Docket Number:	19-SB-100
Project Title:	SB 100 Joint Agency Report: Charting a path to a 100% Clean Energy Future
TN #:	240581
Document Title:	Bioenergy Association of California Comments - Bioenergy Association of California Comments on Non-Energy Benefits Analysis for SB 100
Description:	N/A
Filer:	System
Organization:	Bioenergy Association of California
Submitter Role:	Public
Submission Date:	11/12/2021 12:38:03 PM
Docketed Date:	11/12/2021

Bioenergy Association of California Comments on Non-Energy Benefits Analysis for SB 100

**Re: Comments on SB 100 Workshop on Non-Energy Benefits,
Social Costs and Reliability**

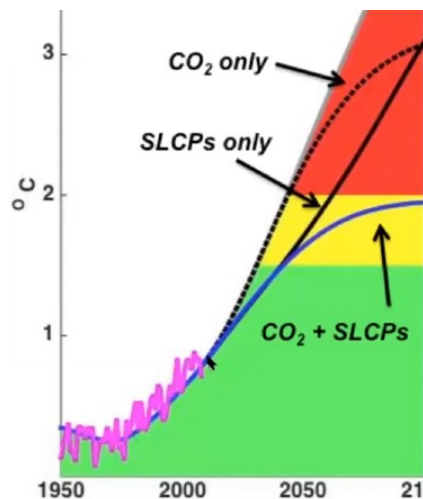
The graphic below from UC San Diego's Scripps Institute¹ shows clearly that focusing solely on fossil fuel reductions – which reduce CO₂ emissions – will not benefit the climate until 2050 or later and that only SLCP reductions bend the warming curve right away. The graph also shows that we will need both CO₂ reductions and SLCP reductions to meet our long-term climate goals.
